Access Compliance Report

Public Rights-of-Way

(Curb Ramps)

Intersection ID: 47839	Main Street: PECO_RD	Cross Street: ALVARADO_WY	Location: E
ADA ID: 5162C7FC6BFC	Ramp Type: PerpDiag	Initial Pass/Fail: Fail	Overall Compliance: No
Severity Score: 21.25			
Codes/Mitigation Info/Possible Solution		Field Measurements/Component Compliance

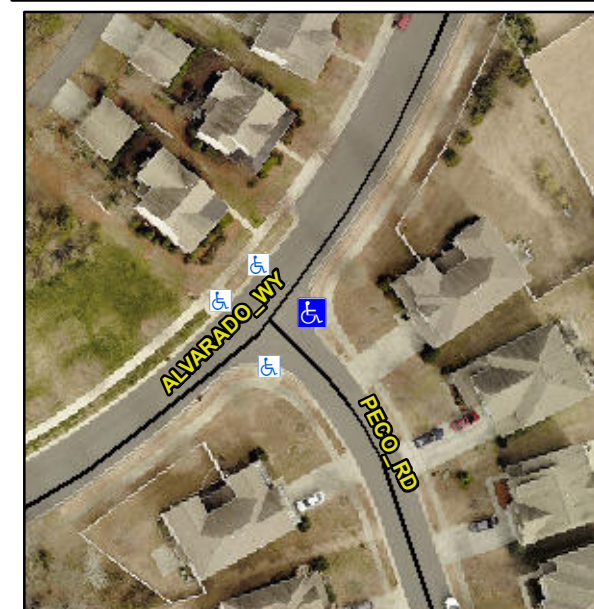
R304.5.1, R304.5.3

Compliance	Description	Data	Compliance	Description	Data
N/A	Ramp Length (in)	133.0	Yes	Ramp Slope (%)	7.4
No	Ramp Width (in)	47.0	No	Ramp XSlope (%)	6.0
N/A	Flare Type LT	N/A	N/A	Flare Type RT	N/A
N/A	Flare Slope LT (%)	N/A	N/A	Flare Slope RT (%)	N/A
N/A	Flare Traversable LT?	N/A	N/A	Flare Traversable RT?	N/A
N/A	Landing Length (in)	N/A	N/A	DWS Provided?	N/A
N/A	Landing Width (in)	N/A	N/A	DWS Contrast?	N/A
N/A	Landing Slope (%)	N/A	N/A	DWS Length (in)	N/A
N/A	Landing X Slope (%)	N/A	N/A	DWS Full Width?	N/A
N/A	Landing Curb? (Y/N)	N/A	N/A	DWS Offset (in)	N/A
N/A	Shared Landing?	N/A			
N/A	Gutter Ponding?	N/A	N/A	Gutter Slope (%)	N/A
N/A	Gutter Lip Ht (in)	N/A	N/A	Gutter X Slope (%)	N/A
N/A	Painted X Walk1?	No	N/A	Painted X Walk2?	No
	X Walk 1 Direction	To NW		X Walk 2 Direction	To SW
N/A	X Walk 1 Width (in)	N/A	N/A	X Walk 2 Width (in)	N/A
	X Walk 1 Slope (%)	3.0		X Walk 2 Slope (%)	0.3
	X Walk 1 X Slope (%)	1.0		X Walk 2 X Slope (%)	3.3

Remove & Replace Curb Ramp With Two New Directional Ramps or Equivalent.
